## **NOTICE OF A TYPE II DECISION ON A PROPOSAL IN YOUR NEIGHBORHOOD**

### **CASE FILE NUMBER: LU 17-286584 DZ – ROOFTOP SOLAR**

The applicant seeks design review approval for the installation of a solar energy system on the roof of an existing building. The structure is a single-family house built in 1904 and it is located at the corner of N Maryland Avenue and N Webster Street the North Interstate Plan District and in the Central Employment (EX) zone. The proposed solar array consists of black panels with black frames on a dark roof on the south face of the primary roof gable, on the south facing shed roof of an existing dormer, and on the west face of an existing gable dormer facing an interior lot line. The proposed panels are to be installed a minimum of 3 inches and a maximum of 6 inches from the face of the roof surface and are proposed to be a minimum of 1 foot from roof ridgelines, and 2 feet from primary roof eaves. Accessory equipment for the solar array (meter, breaker box, and load center) is also proposed on the north elevation at the northwest corner of the building.

EXH C-3  
LV 17-266504DZ

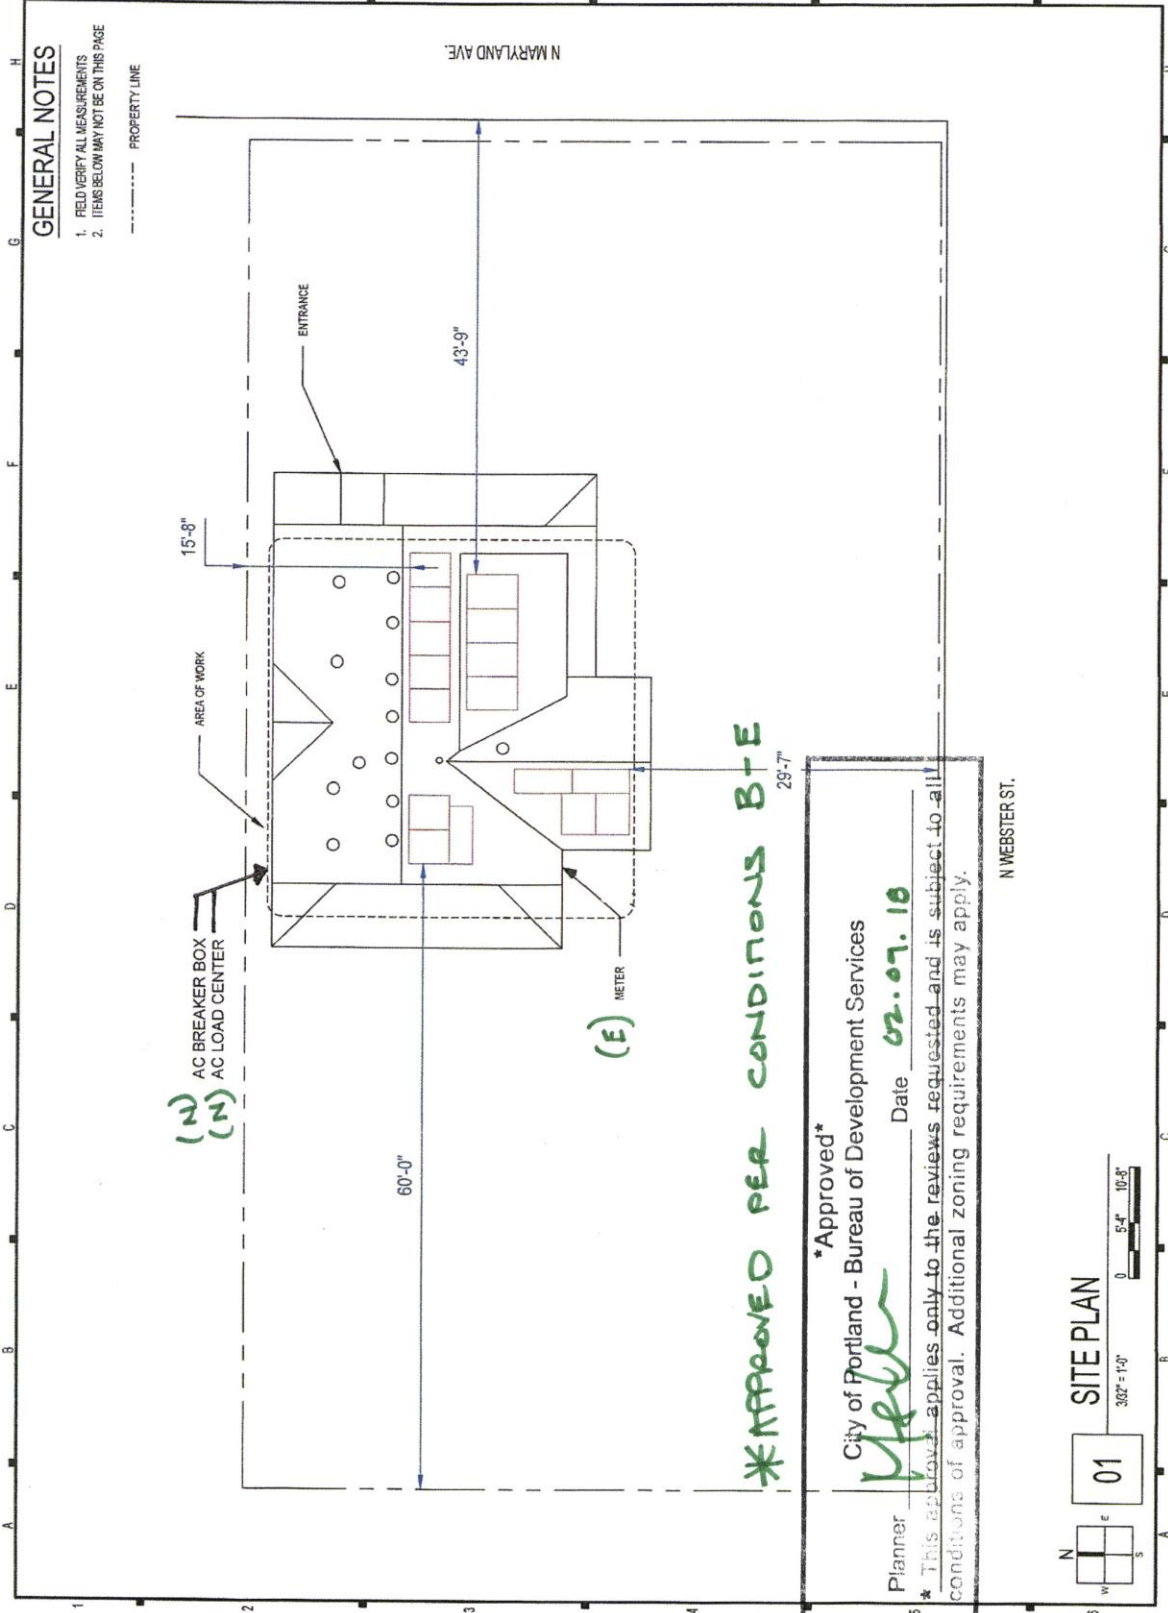
**Findings for P1, D6, D7, D8:** The proposed solar array consists of black panels with black frames on a dark roof on the south face of the primary roof gable, on the south facing shed roof of an existing dormer, and on the west face of an existing gable dormer facing an interior lot line. The proposed panels are to be installed a minimum of 3 inches and a maximum of 6 inches from the face of the roof surface and are proposed to be a minimum of 1 foot from roof ridgelines, and 2 feet from primary roof eaves. Accessory equipment for the solar array (meter, breaker box, and load center) is also proposed on the north elevation at the northwest corner of the building.

- The proposed arrays will be parallel to the roof slope on which they are attached;
- The proposed arrays will be offset no more than 6” from the top of the roof shingles to the top of the panels.
- All proposed panels will be black panels with black frames and will blend into the dark roof surface; and
- All proposed accessory equipment (the breaker box and load center) will not be mounted to the north façade of the building and will not be visible from the street.

- C. The proposed array shall consist of black panels with black frames.
- D. The proposed arrays shall offset no more than 6” from the top of the roof shingles to the top of the panels.

\*APPROVED PER CONDITIONS B-E
